ADDENDUM No. 2

Reference: Security Improvements – Decker Lake Youth Center
Division of Juvenile Justice Services
DFCM Project No. 08009430

Addendum Number #2

ADD-01

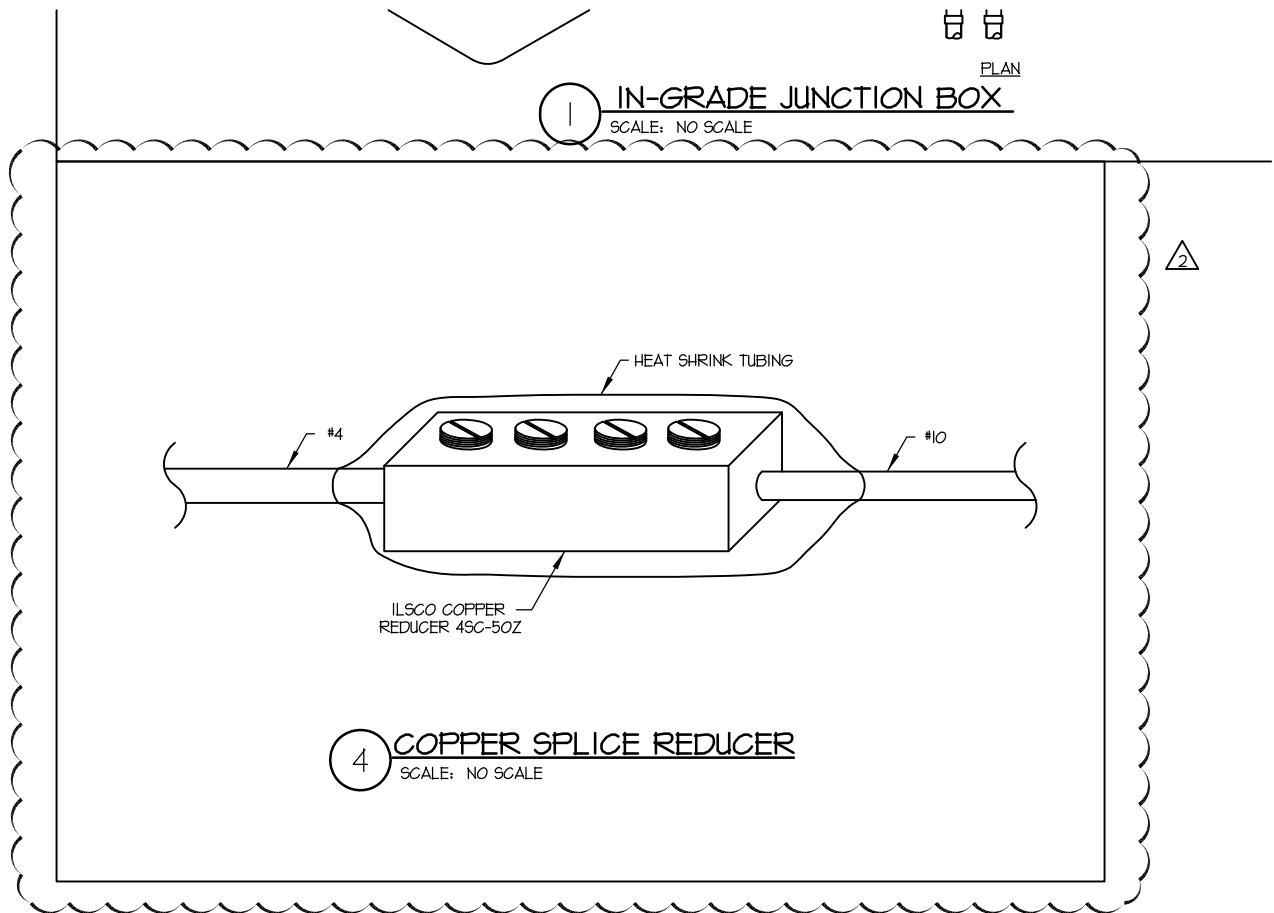
SHEET EG001: SYMBOLS

1. ADDED GENERAL CAMERA/FIBER NOTES

GENERAL CAMERA/FIBER NOTES:

1. ELECTRICAL CONTRACTOR IS NOT RESPONSIBLE TO INTEGRATE THE NEW DVR INTO THE EXISTING SYSTEM. CONTRACTOR IS ONLY REQUIRED TO PROVIDE TERMINATIONS AND TESTING FOR THE FIBER.
2. THE OWNER PROVIDED DVR IS AN ADVENT BRAND PELCO PROTOCOL. ELECTRICAL CONTRACTOR TO INSURE SYSTEM COMPATABILITY WITH OWNER PROVIDED DVR.
3. THE EXISTING CAMERA SWITCH IS A PELCO MATRIX.

ADD-02

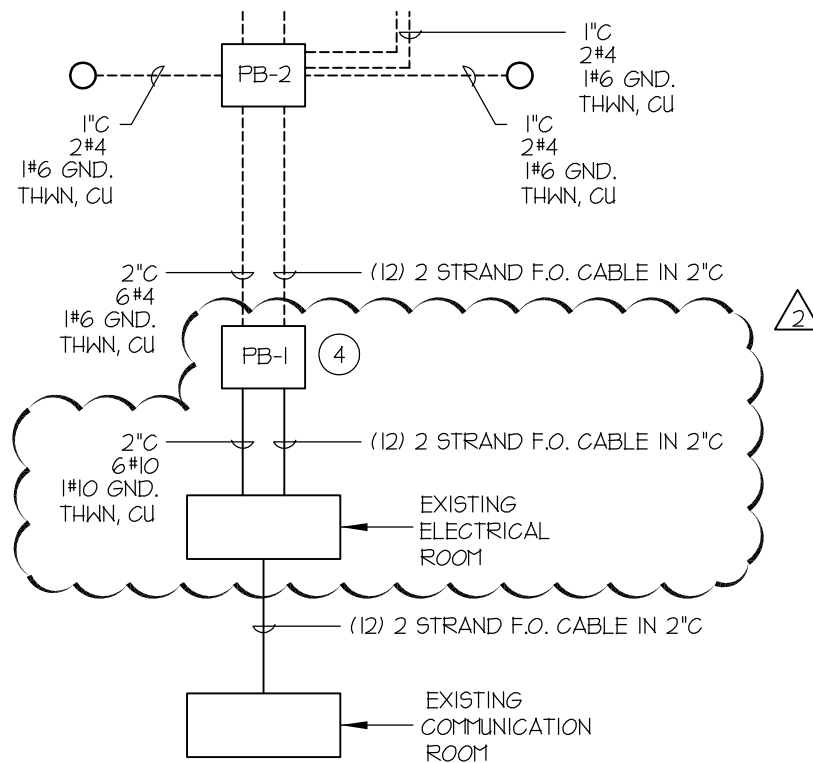
SHEET EG002: DETAILS

1. ADDED DETAIL 4/EG003

ADD-03

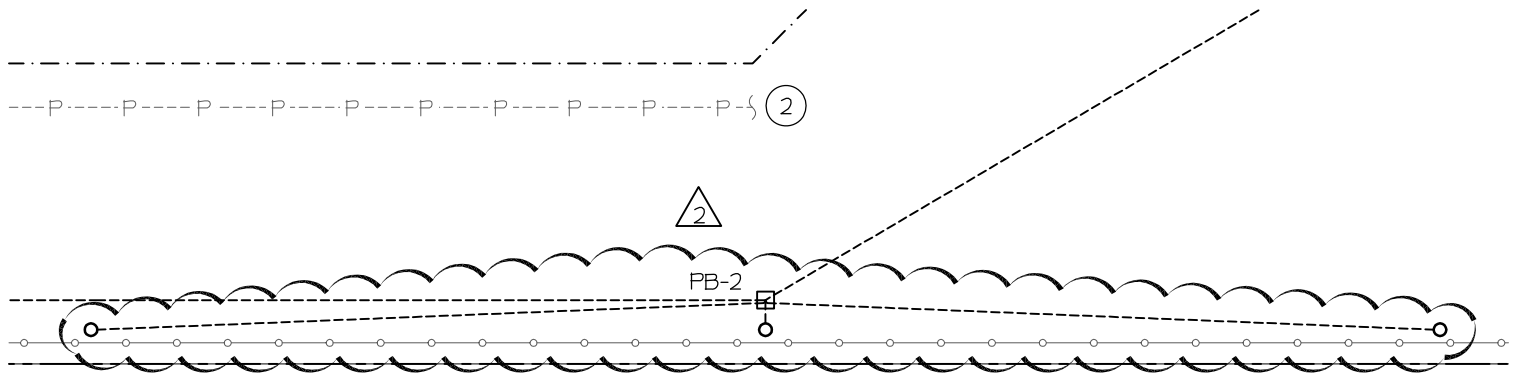
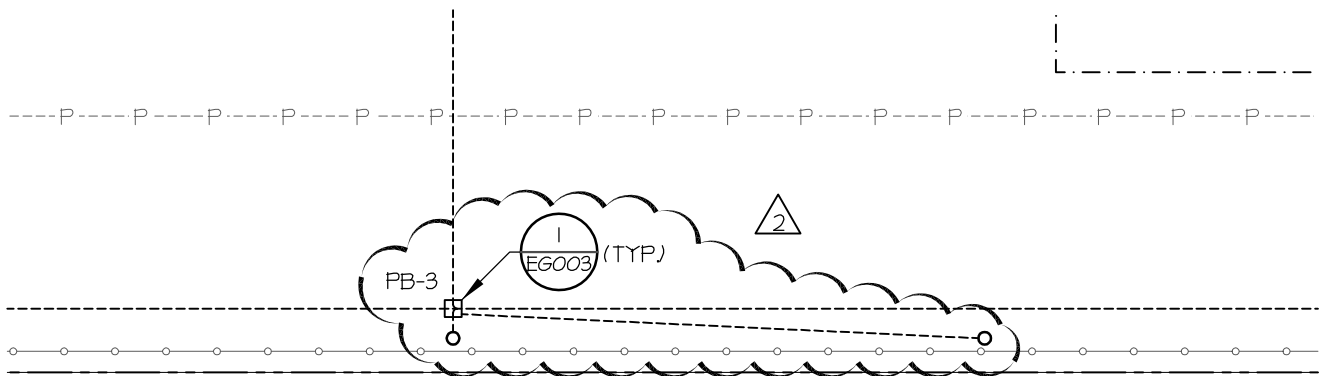
SHEET ES100: SITE CONDUIT PLAN (SEE

1. MADE CHANGES TO CONDUIT RACEWAY DIAGRAM
2. SHOW CONDUIT COMING OUT OF PULL-BOXES TO EACH LIGHT POLE.

1 CONDUIT RACEWAY DIAGRAM
SCALE: NONE

- (4) PROVIDE SPLICE FROM #4 TO #10 WITHIN PB-1. SEE DETAIL 4/EG003 FOR ADDITIONAL INFORMATION.
